**CITY OF RAMSEY LAND USE APPLICATION
TECHNICAL REVIEW FILE**

DATE	FEBRUARY 24, 2017	PROJECT ADDRESS	TBD
PROJECT. TITLE	COVENANT MEADOWS: PRELIMINARY PLAT AND REZONING		
ESCROW #	115528		
DEPARTMENT:	Community Development: Planning Division		
TECHNICAL REVIEWER:	Name: Eric Maass, Consultant Planner Phone: 763-433-4302 Email: EMaass@wsbeng.com

Preliminary Plat Review

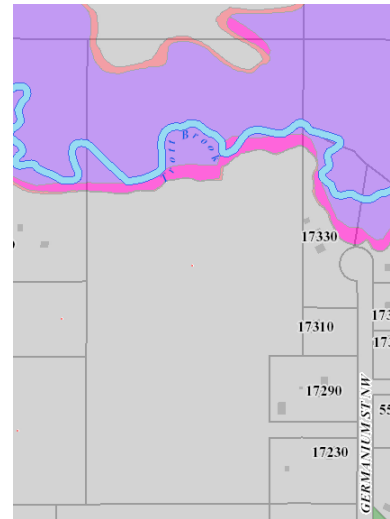
Floodplains. There are floodplains within the boundaries of the project area, including both Floodway and Floodfringe. There shall be no fill placed within the Floodway (purple shading).

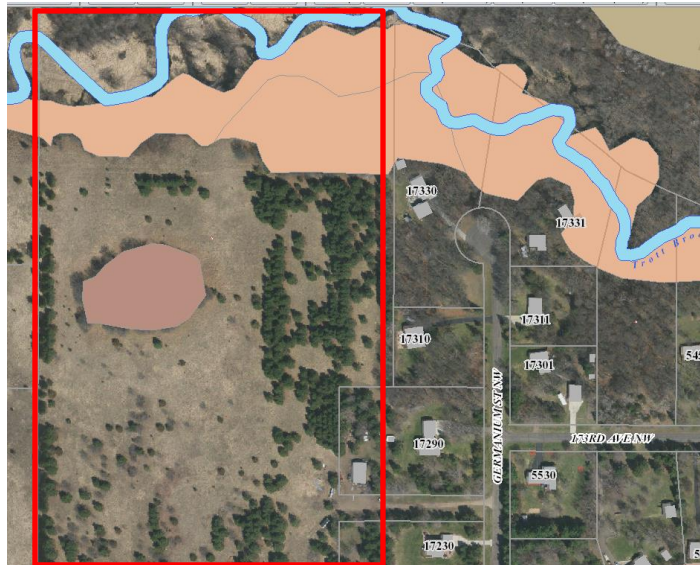
The City’s Natural Resources Inventory (NRI) identifies some moderate quality forest floodplain and oak woodlands adjacent to Trott Brook and a high quality oak woodland in the north central portion of the site. Most, if not all of the moderate quality areas are within the proposed Outlot A, which is to be deeded to the City as part of the Planned Unit Development (PUD). Per the Tree Inventory and Preservation Plan, it appears that much of the high quality oak woodland will also be preserved through the development process.
